CONSTRUCTION PLANS
FOR
**PONDEROSA AT
LORSON RANCH FILING NO. 3**
STREET/STORM SEWER AND UTILITY CONSTRUCTION PLANS

COVER SHEET
STREET/STORM SEWER
AND UTILITY PLANS

PUDSP-19-010

SIGNING PLAN
PONDEROSA AT LORSON
RANCH FILING NO. 3

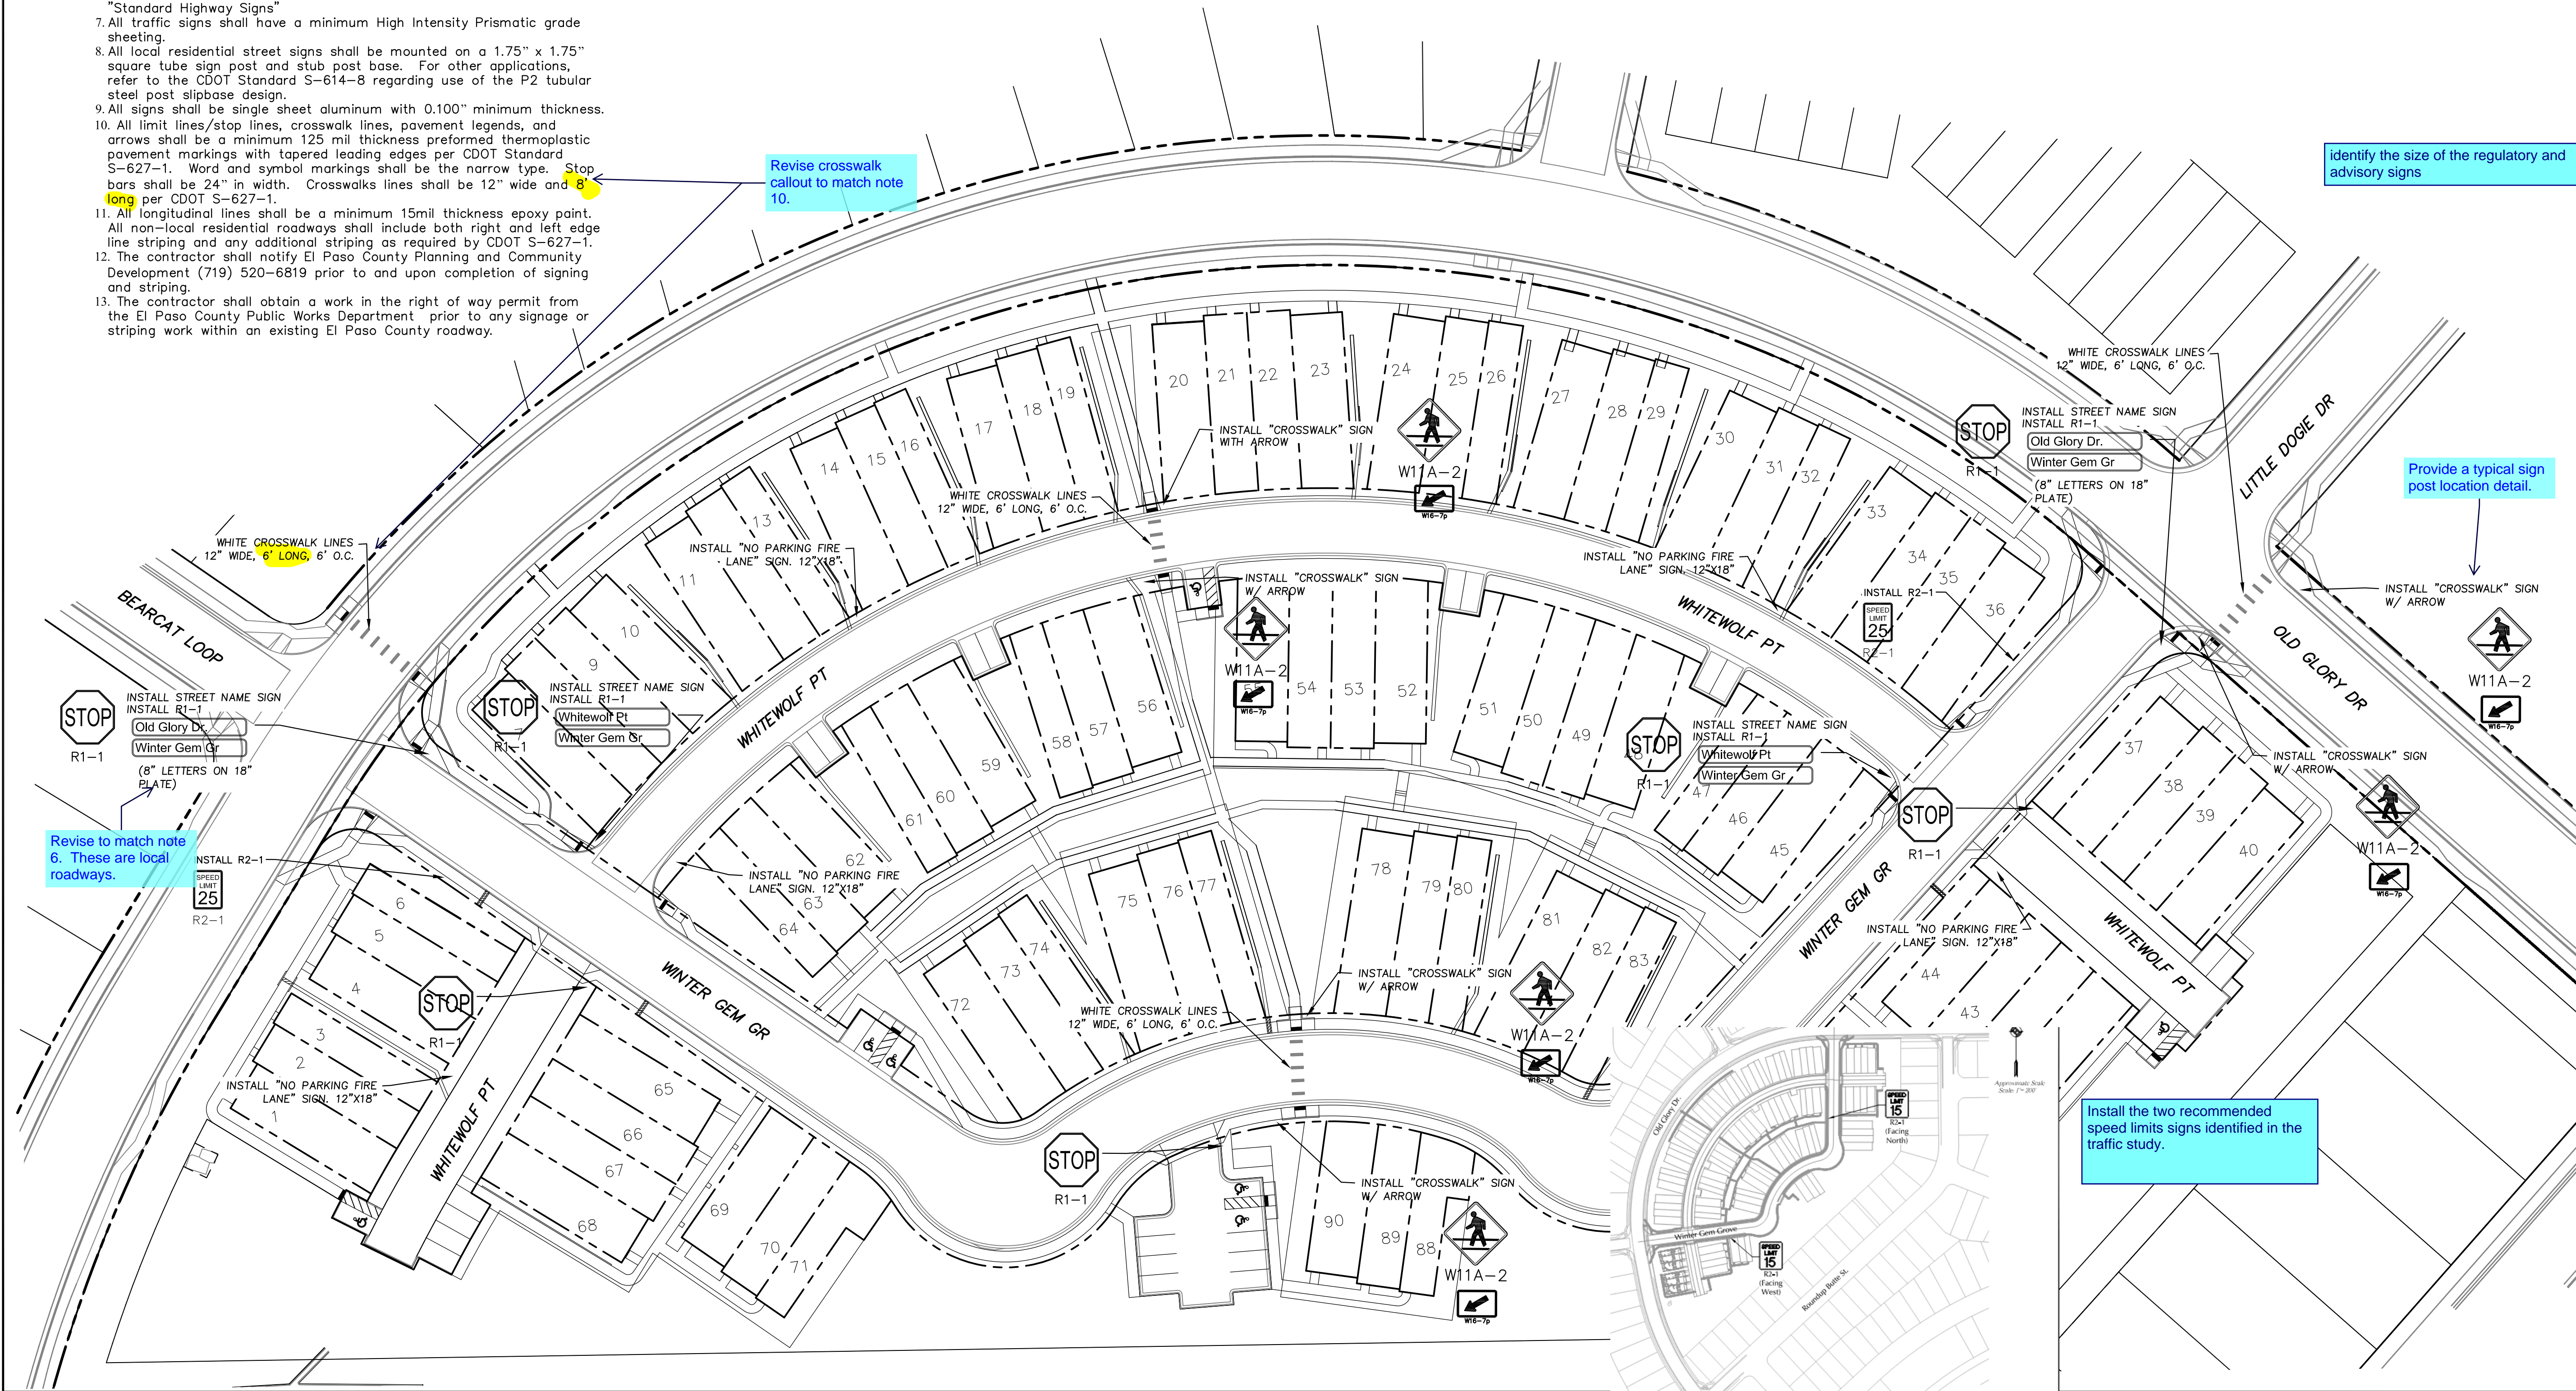
Revise crosswalk callout to match note 10.

Provide a typical sign post location detail.

Revise to match note 6. These are local roadways.

DATE:
 APR 8, 2020
 PROJECT NO.
 100.050
 SHEET NUMBER
 C6.1
 TOTAL SHEETS: 30

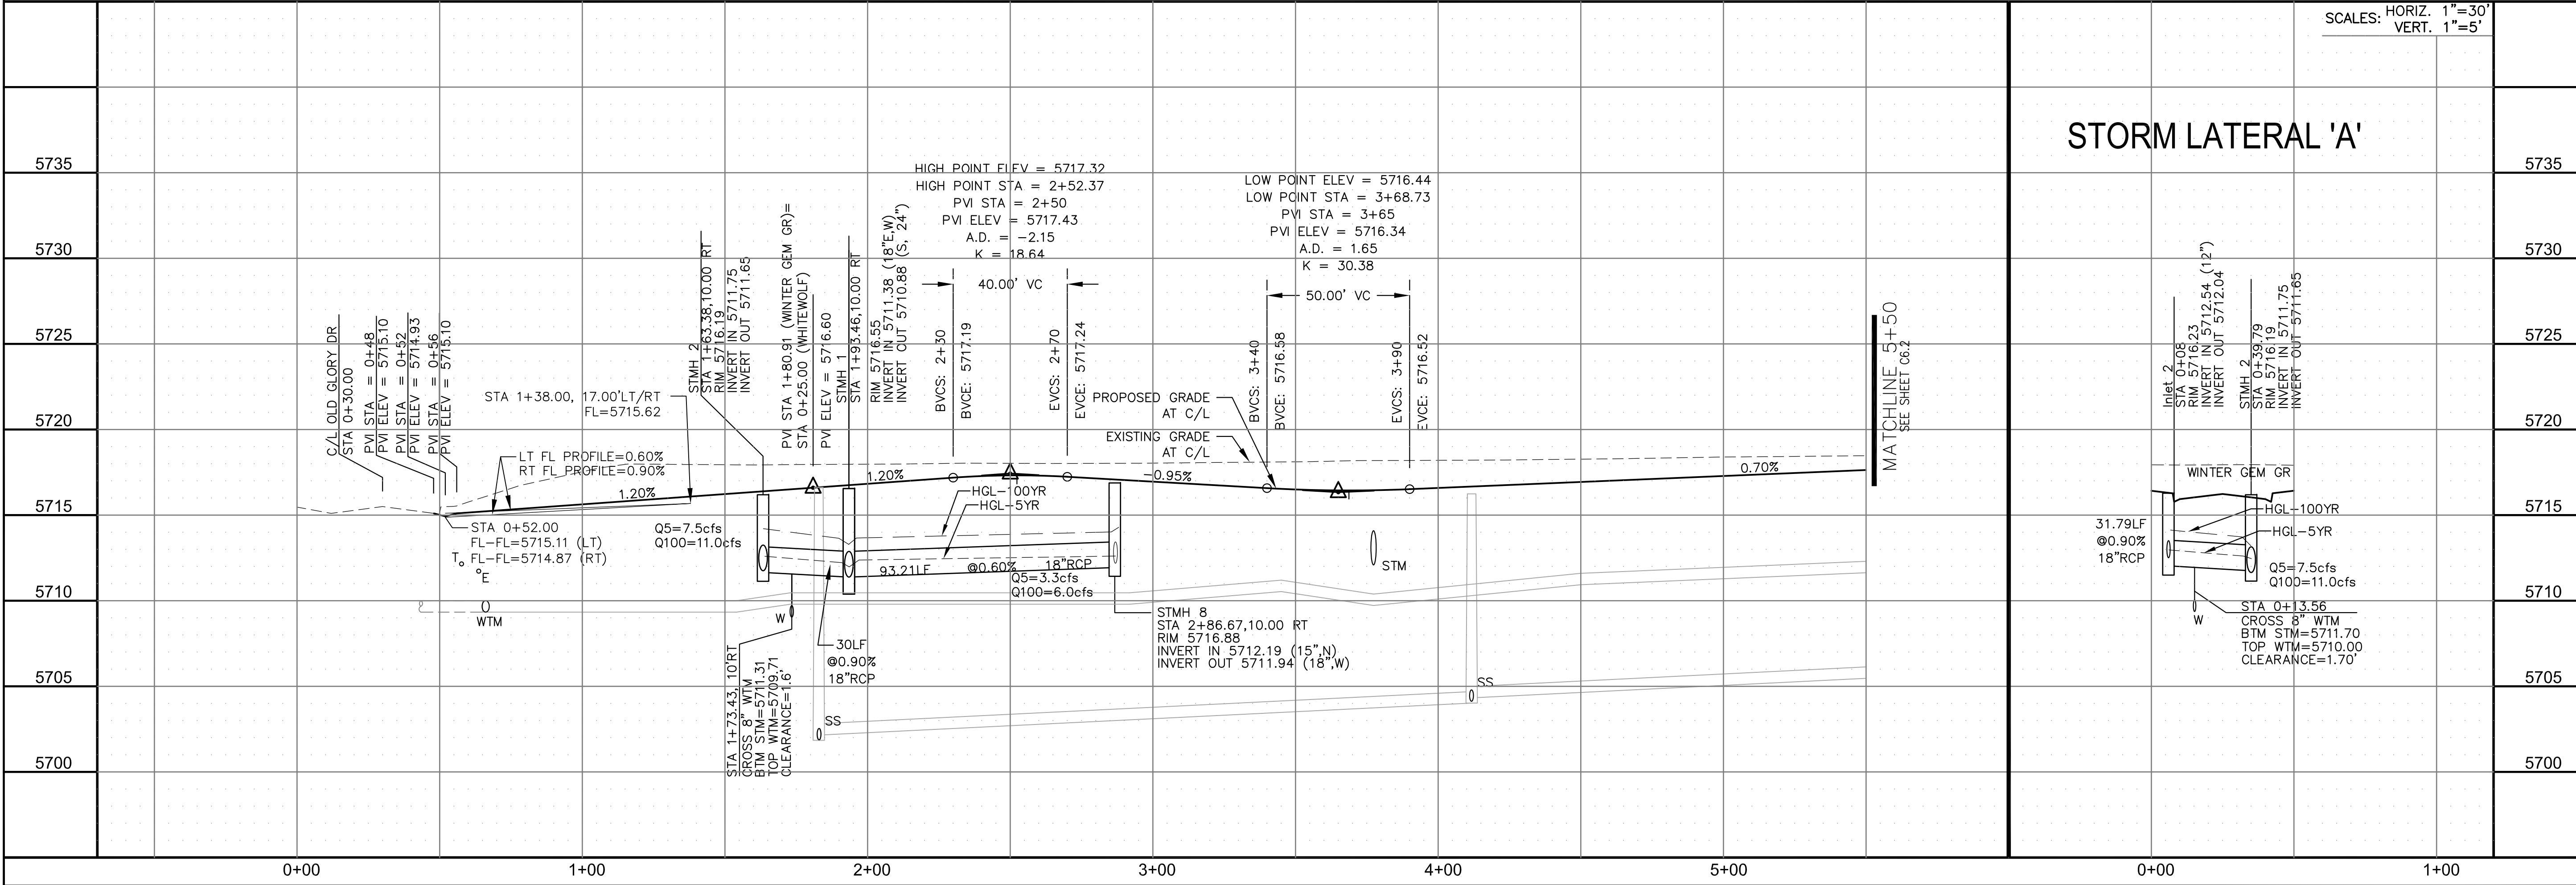
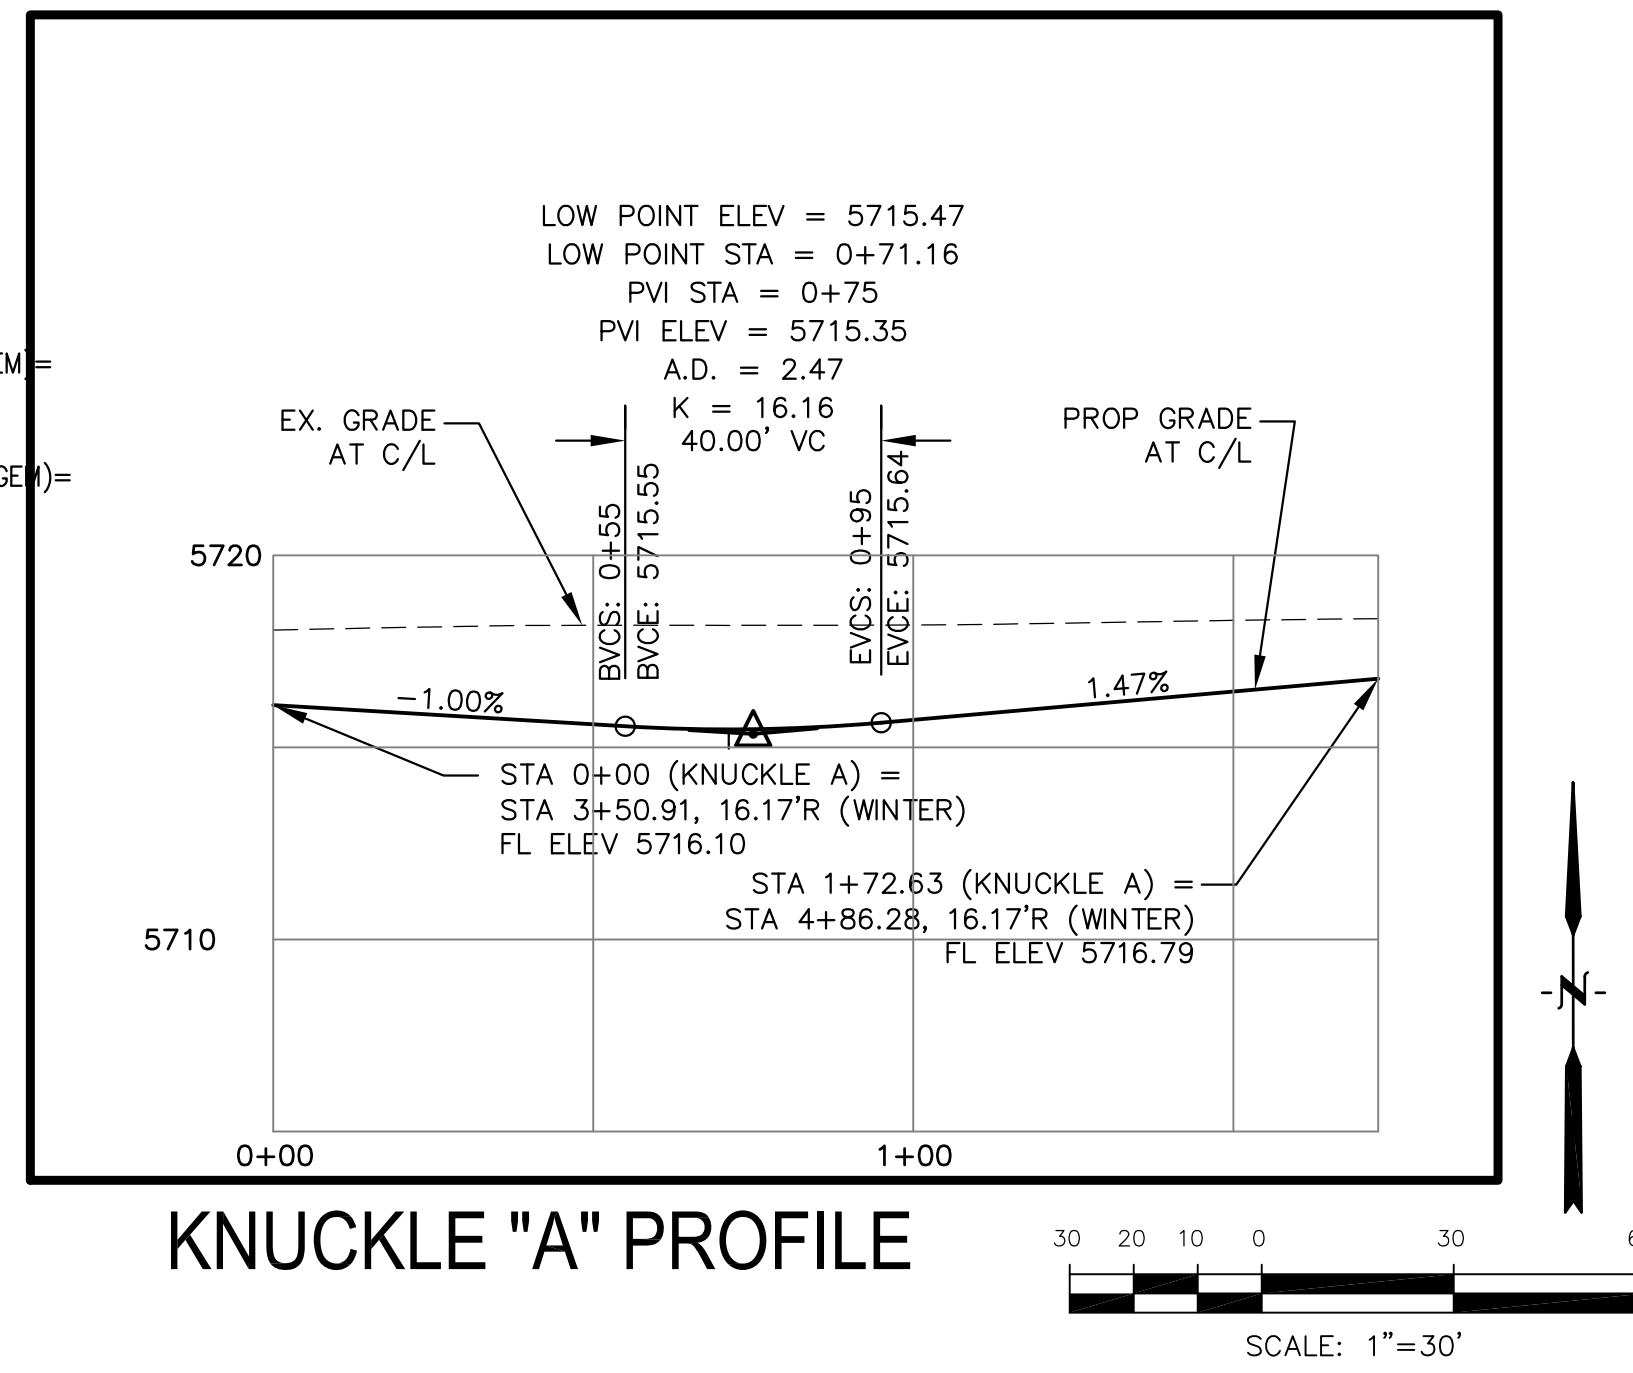
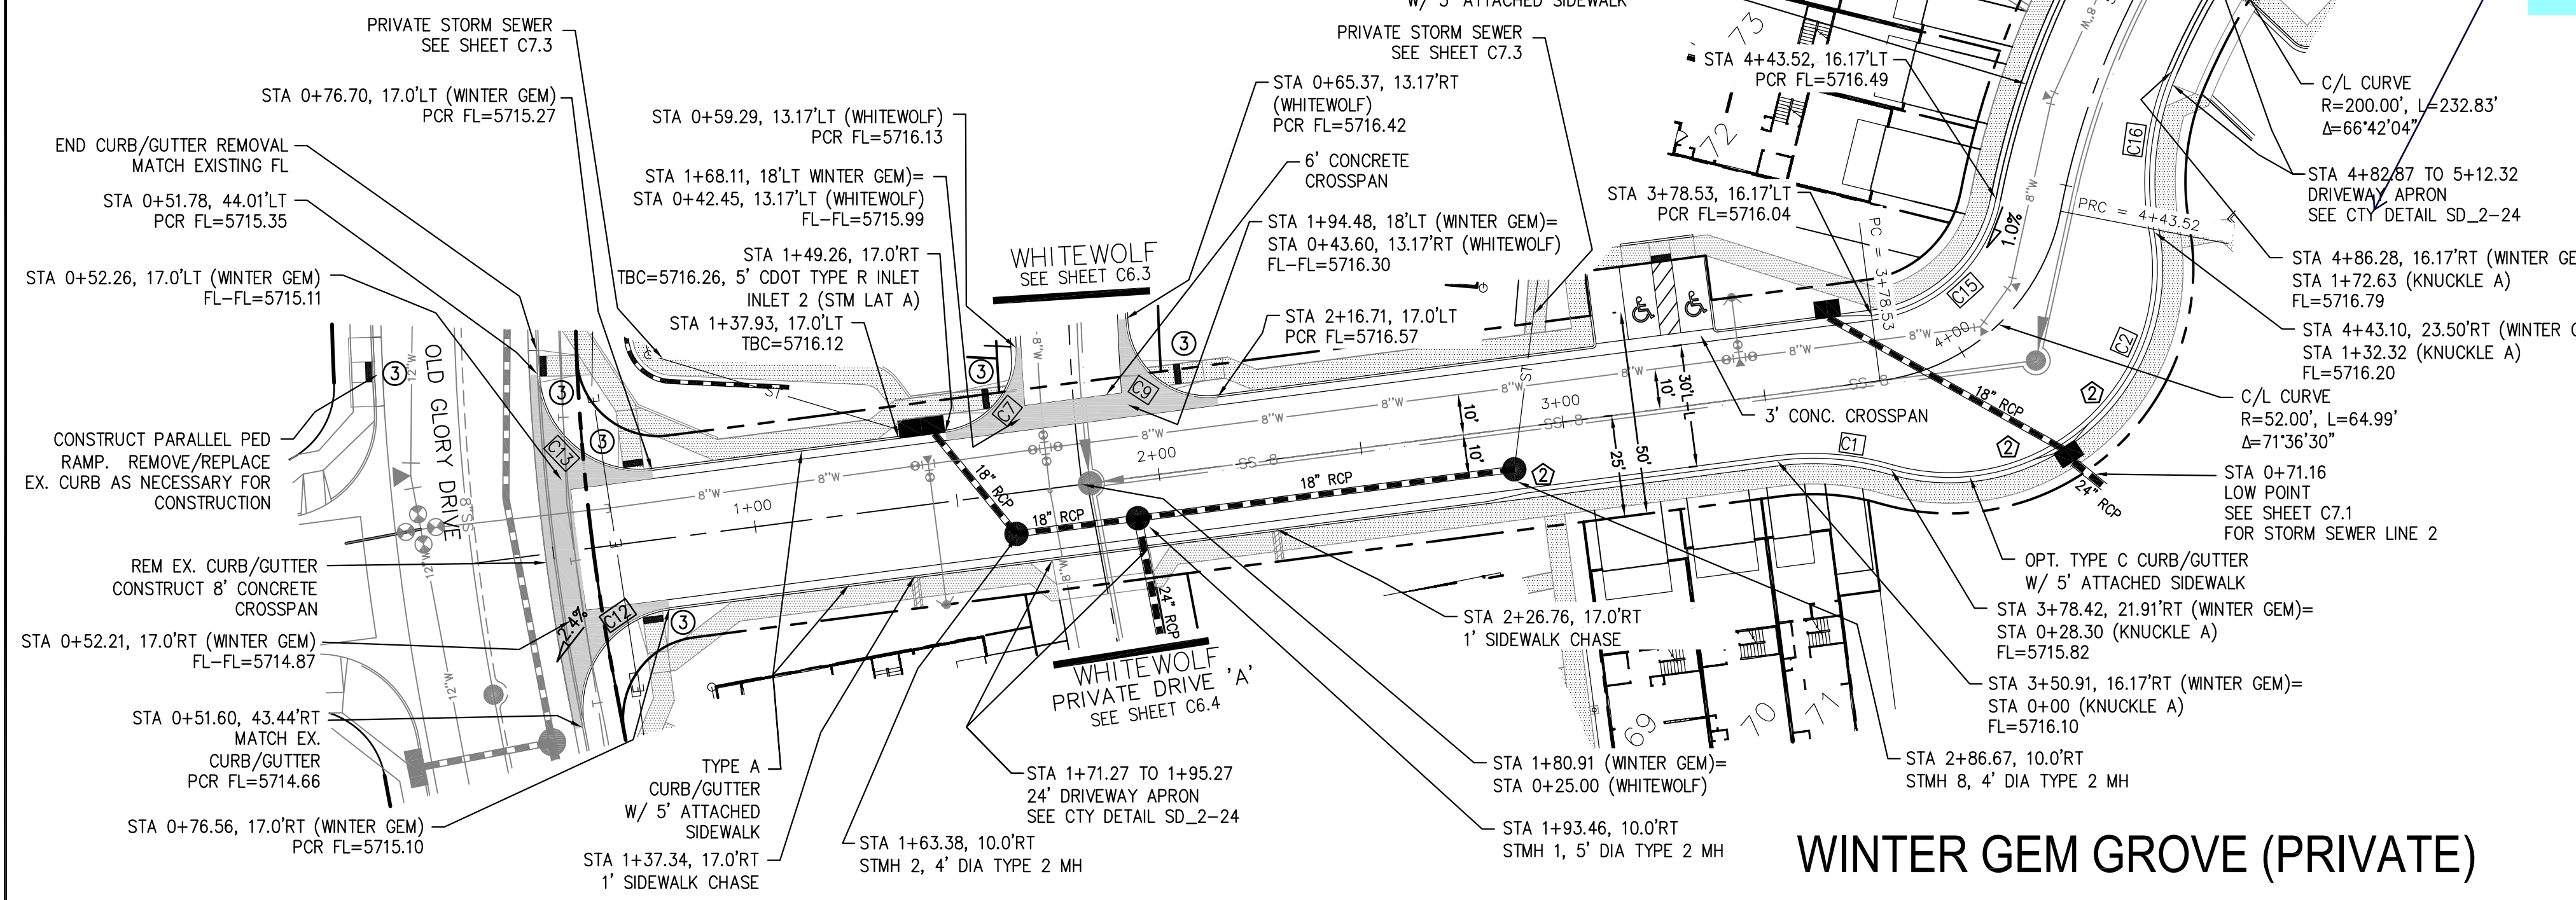
Add an abbreviations list for all abbreviations used such as CTY, STA, FL, etc.
